PRELIMINARY OVERALL AREA DEVELOPMENT PLAN
for
RAINTREE SUBDIVISION
"A Morton Southwest Development"

RE: Raintree POADP
Amendment dated July 2, 1986
File #83-20-63-44

RE: Raintree POADP
(File #83-20-63-44)
Reviewed November 25, 1985

Re: Raintree
File #: 83-20-63-44

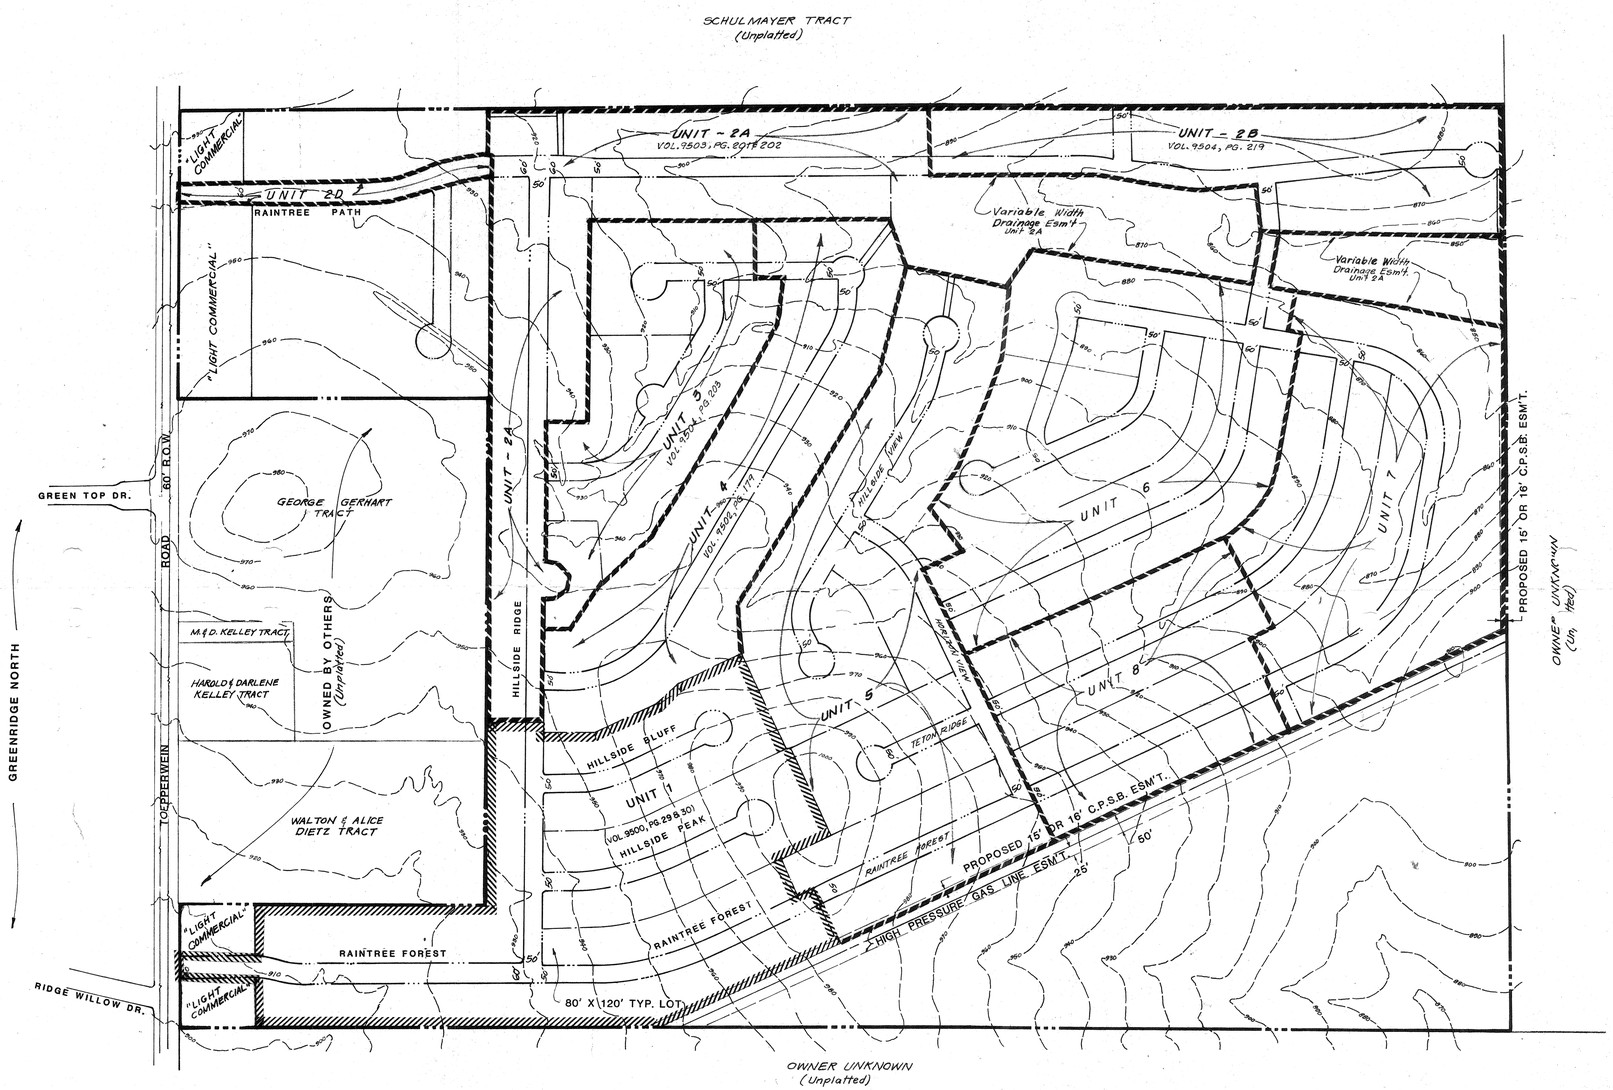
Revised POADP reflects new street design in Unit-6

PRELIMINARY OVERALL AREA DEVELOPMENT PLAN
for
RAINTREE SUBDIVISION
"A Morton Southwest Development"

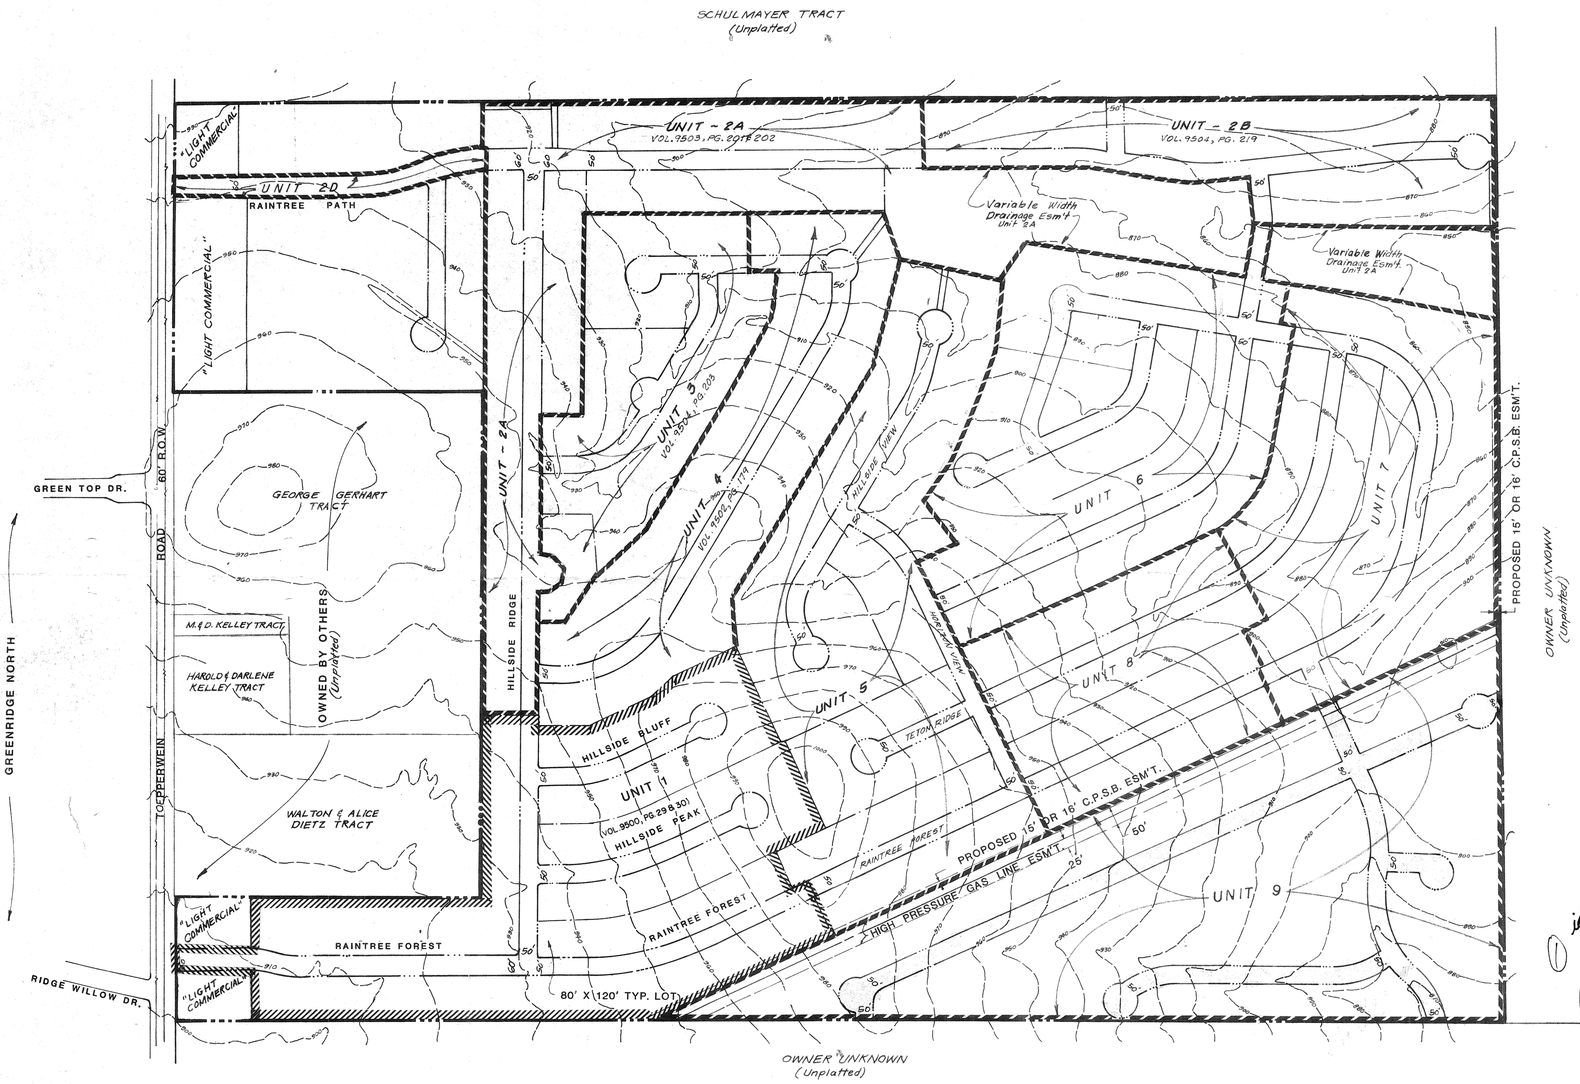
Revised Plan shows layout for Unit 9

① identify collector & type "B" street
② all adjacent sewer dwg
③ Wrecky.

PRELIMINARY OVERALL AREA DEVELOPMENT PLAN
for
RAINTREE SUBDIVISION
"A Morton Southwest Development"

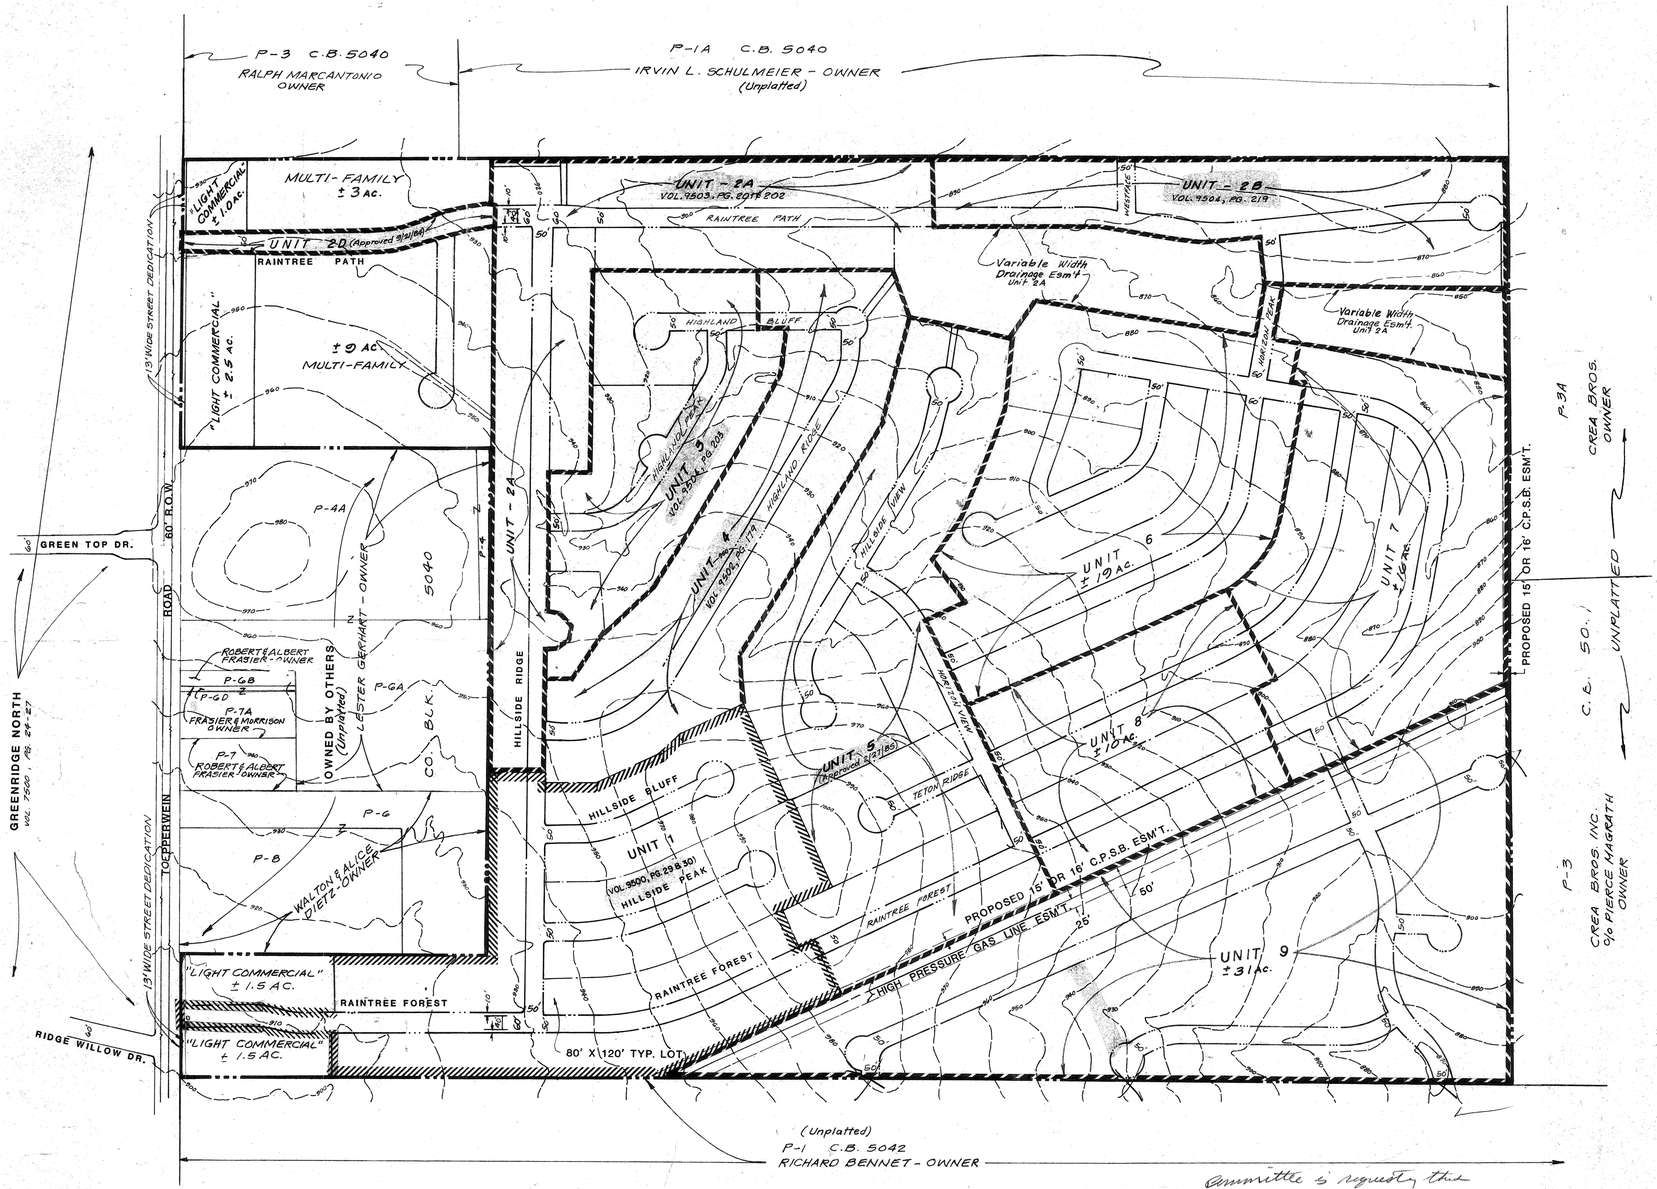
Revised plan reflects new design for Unit 9 & has been updated

Committee is requesting that a street be developed to lessen the cul-de-sac street length and provide for a better circulation.

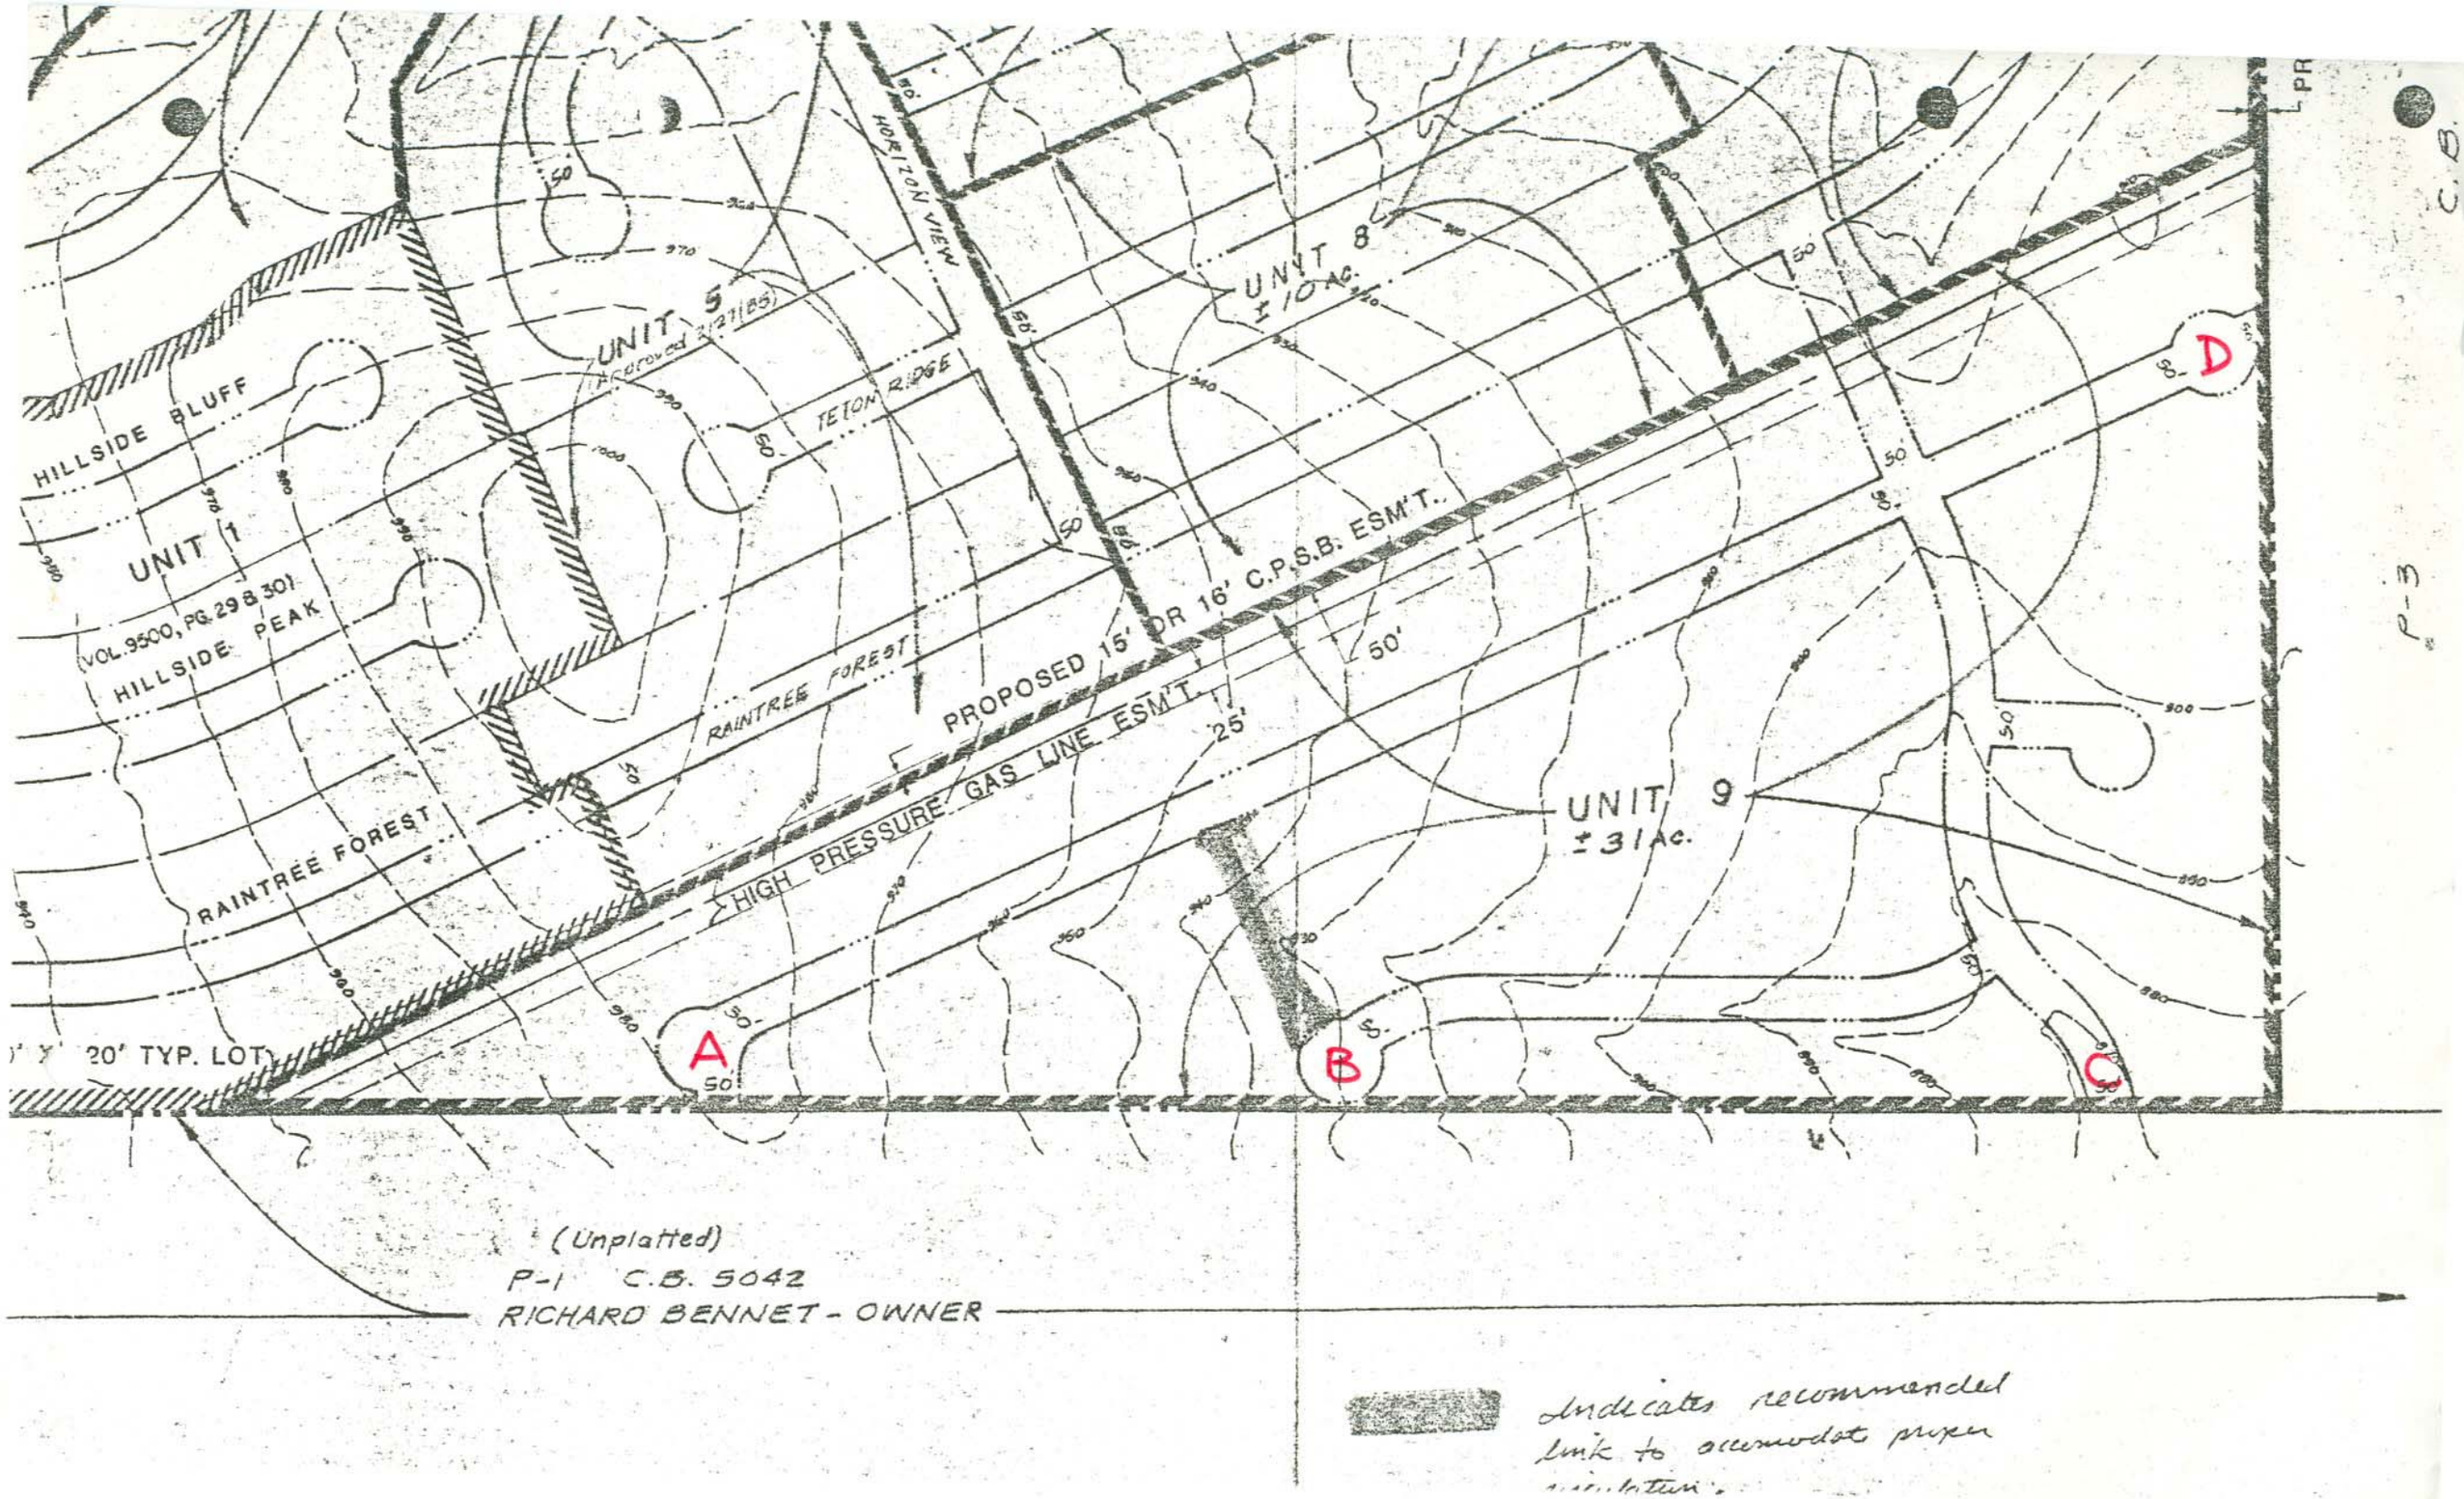
The POADP Committee reviewed the Raintree Plan and recommends that only one stub street be provided at point C on the attached sketch.

For your information, the staff policy is that stub streets should be collectors with a 60 foot right-of-way. In this instance we see no need for a 60 foot right-of-way as Raintree Forest is only 50' also. If this recommendation is unacceptable we are available to discuss other alternatives. Thank you for your cooperation in this matter and please call our office at 299-7900 if you have any questions.

I have placed the letters A, B, C, and D on each of the stub streets shown on the sketch. Would you please call me at 655-4420 when it is convenient - to let me know which stub streets the committee wishes to see eliminated.
